TRUSTEES FOR ALASKA

July 1, 2019

Re: Comments on the Draft Environmental Impact Statement and Public Notice of Application for Permit Reference Number POA-2017-00271 for the Proposed Pebble Project

2019 Wobus Memo - Figure 6. Probability of a tailings storage facility failure vs time.¹⁴⁰⁷

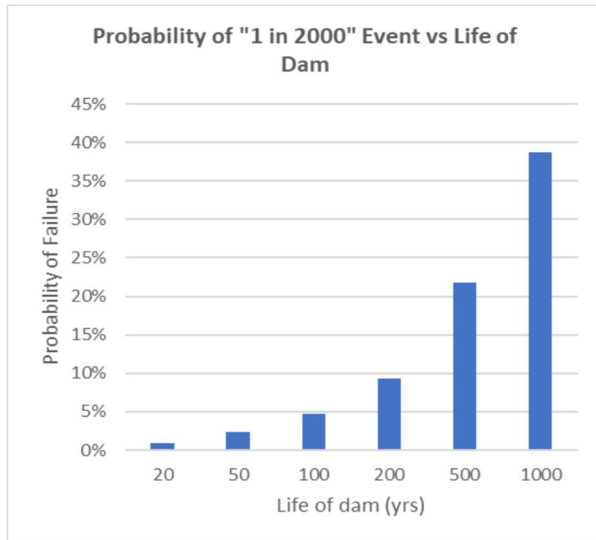
As noted above, the reasoning offered to preclude review of a variety of tailings failures, including complete failures of both north and south embankments, is inconsistent with the requirements of NEPA. Given that the 78-year mine is a reasonably foreseeable future action, the 20 years is an inappropriate time period; any assessment must at least analyze a 78-year life span and the potential cumulative impacts from an expansion from a 20-year mine to a 78-year mine. Those potential impacts include tailings failures. Further, since the water balance calculations indicate that the bulk tailing facility may remain saturated indefinitely, the risk of a tailings failure will remain in perpetuity.¹⁴⁰⁵ The DEIS indicates that the probability of a tailings storage facility dam failure is approximately 1 in 2000, for every year of dam's life.¹⁴⁰⁶

2019 Wobus Memo. - Figure 7. Tailings flood extent from median tailings dam failure scenario (Lynker, 2019)¹⁴⁴²

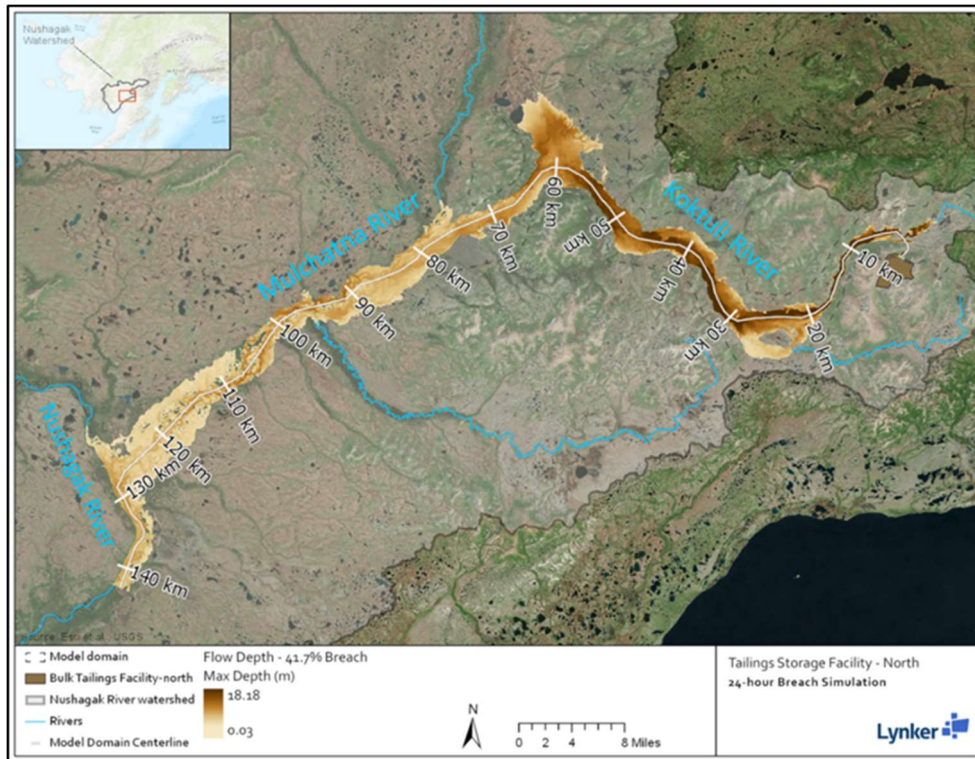
The Lynker tailings failure scenario "found that a full [tailings storage facility] failure could impact hundreds of miles of salmon-producing streams, with potentially catastrophic long-term consequences to salmon habitat"¹⁴⁴¹ The Lynker study demonstrates that, despite the probability of failure, the consequences of such an event would be significant.

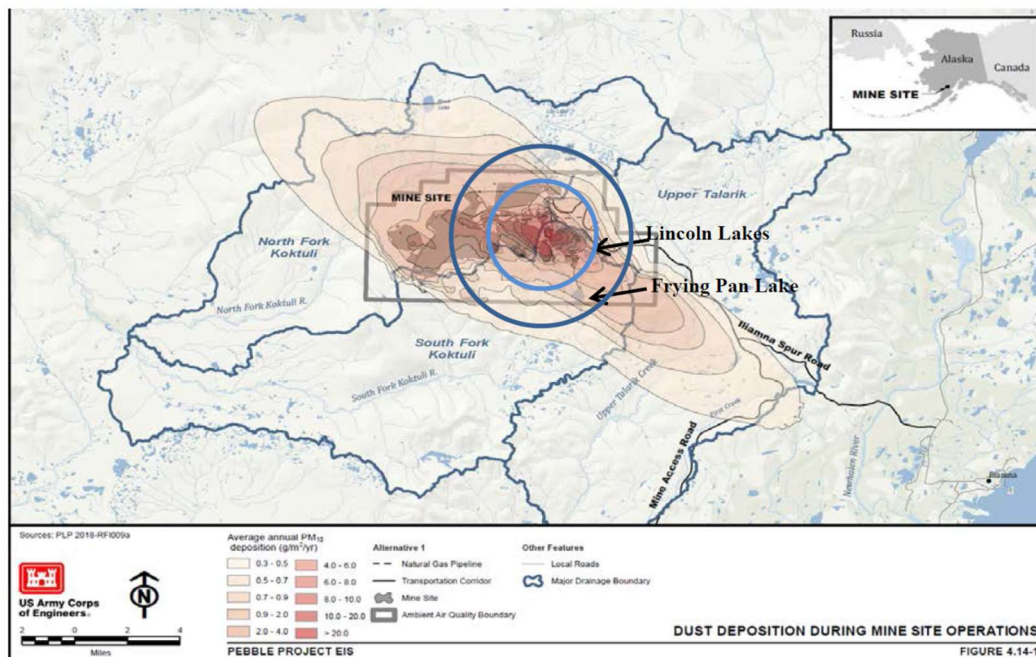
The DEIS analysis for the mine site is also limited by the arbitrary 330-foot dust zone. As discussed above, this limited impact analysis area fails to accurately capture and portray the anticipated dust impacts that will extend beyond 330 feet.¹⁶⁸⁸ Notably, the DEIS recognizes that dust will travel further than 330 feet through its depiction of mine site dust deposition in Figure 4.14–1.¹⁶⁸⁹ The following figure in the Zamzow et al. 2019 report includes an overlay of concentric rings at 2 and 4 miles out from the pit:¹⁶⁹⁰

As Dr. Zamzow notes, “In the Pebble Project DEIS, the 100 m zone was the sole source relied on to calculate the area of vegetation, wetlands, and water bodies impacted by dust, and is different from the dust plume map shown in Chapter 4.14.”¹⁶⁹¹ This is self-evident after looking at the expanse of dust deposition provided in the DEIS Figure 4.14–1. Because wetlands and water bodies will be impacted far beyond the 330-foot dust zone, the DEIS estimates are inaccurate and misleading. Because fugitive dust is considered a secondary or indirect impact that results in loss of wetlands under the CWA 404 permit review for this project,¹⁶⁹² the estimated indirect loss of wetlands for purposes of the 404 analysis is inaccurate.
